Title: **STAGE 1 QUALITY AUDIT**

Redevelopment of Former Tedcastles Site, Monkstown.

Client: **DBFL Consulting Engineers.**

Report reference: **0739R02**

Appendix B – Problem Location Map.

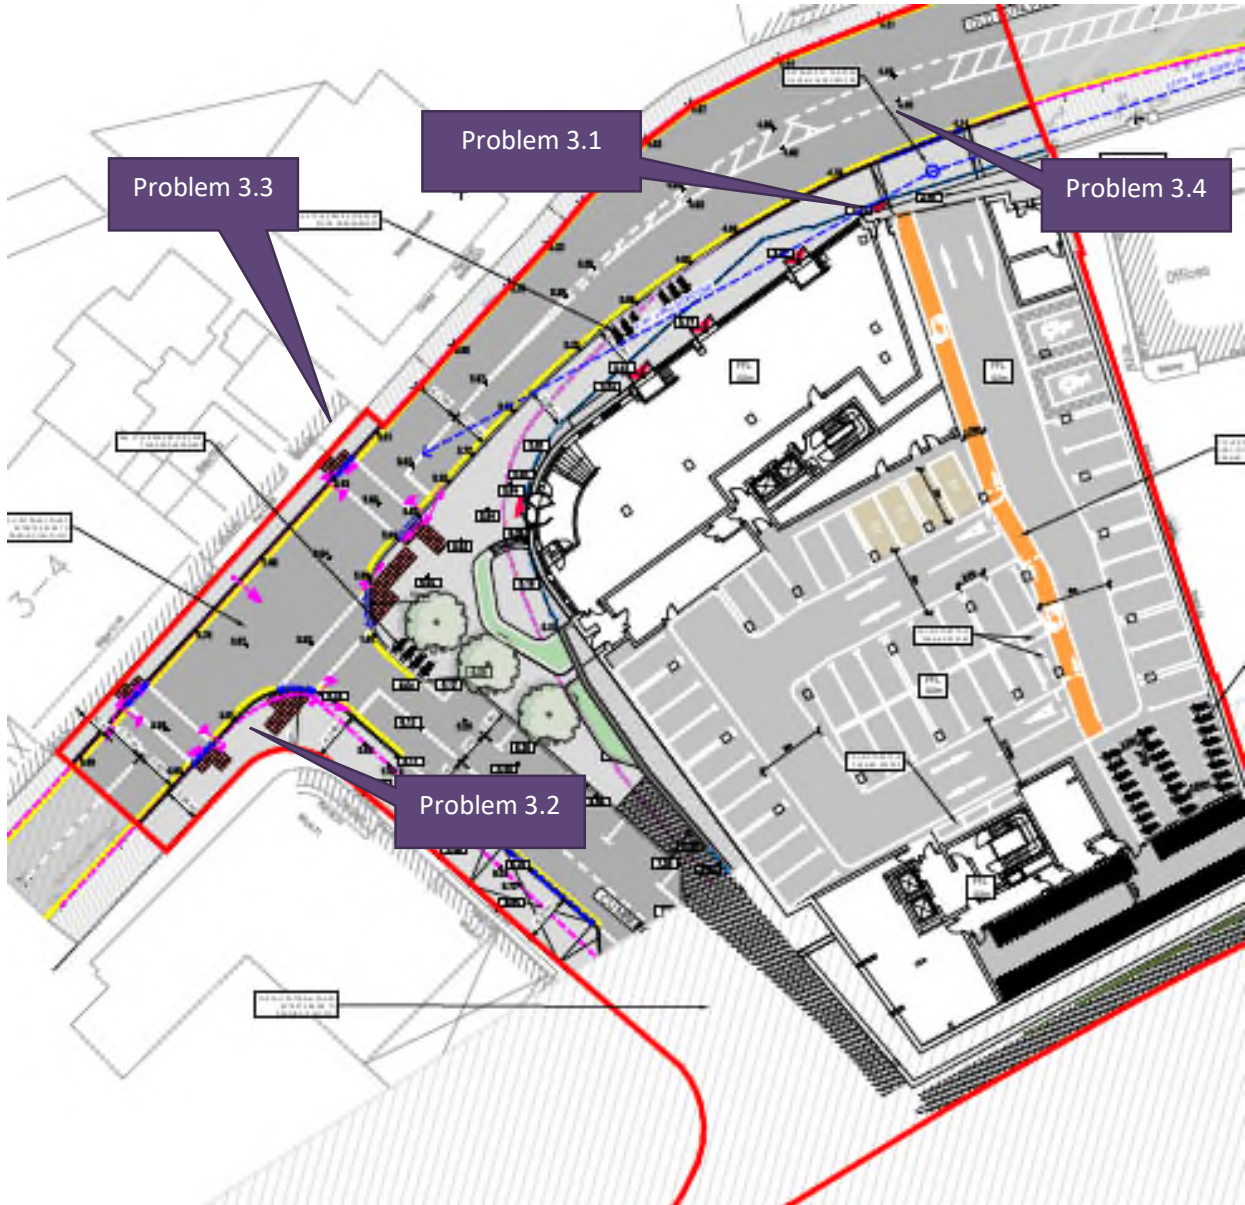
It is proposed to provide signalised pedestrian crossings on Old Dunleary Road that cross both the carriageway and the cycle track. It is important that cyclists stop in advance of the crossings to allow pedestrians safe passage across.

It is recommended that stop lines be provided on the cycle track in advance of the signals and that cyclists be aware that the red traffic signals are not just for vehicular traffic.

There is a substantial ESB pole /PL lighting column on the southern footpath of the N31 which could obscure inter-visibility between pedestrian and drivers at the signalised crossing, resulting in collisions with vulnerable road users.

It is recommended that the pole and services be removed.

The drawing shows the swept path for a two axel refuse truck which encroaches slightly on the cycle track on the N31 for the left turn movement from Cumberland Street. There is a risk that larger vehicles, even three axel refuse trucks will undertake this manoeuvre and may encroach significantly on the cycle track including the rubber kerb which segregates it from the general traffic lane.

It is recommended that an assessment be carried out of the largest vehicles that will undertake this manoeuvre and if necessary the stop line on Cumberland Street should be set back to allow the movement to take place.

It is anticipated that many cyclists will use the signalised pedestrian crossing to access the cycle parking spaces at the surface level and in the basement of the proposed development. There is a risk that the proposed pedestrian crossing will be too narrow to cater for cyclists and pedestrians and this could lead to collisions between the two user groups.

It is recommended that the crossing be wide enough to cater for all future users.

3.1	Yes	Yes	Stop lines have been proposed on the cycle track in advance of the signals as show on DBFL drawing no. TED-DBFL-RD-SP-DR-C-1101 Rev P02. It should be noted that all works in the public realm are subject to agreement with Dun Laoghaire-Rathdown County Council.	Yes

3.2	Yes	Yes	The light pole on the southern footpath along the N31 will be relocated, such that it does not obscure intervisibility between pedestrians and drivers, subject to agreement with the relevant utility service providers and Dun Laoghaire-Rathdown County Council.	Yes

3.3	Yes	Yes	The swept path assessment has been carried out to track the turning movement for a 3-axle refuse vehicle as shown on DBFL drawing no. TED-DBFL-RD-SP-DR-C-1101 Rev P02. This shows a slight protrusion of the vehicle onto the cycle lane during the movement. However, since the intersection is signal controlled, the movement from Cumberland Street will occur when the cycle lanes on the N31 are on a red light and no cyclists will be on the affected portion of the cycle lane thus allowing for a safe movement. It should be noted that	Yes

all works in the public realm are subject to agreement with Dun Laoghaire-Rathdown County Council.	
3.4	Yes	Yes	The proposed crossing on the N31 has been set as 4.0m, as show on DBFL drawing no. TED-DBFL-RD-SP-DR-C-1101 Rev P02, to accommodate all future users which include pedestrians and cyclists. It should be noted that all works in the public realm are subject to agreement with Dun Laoghaire-Rathdown County Council.	Yes
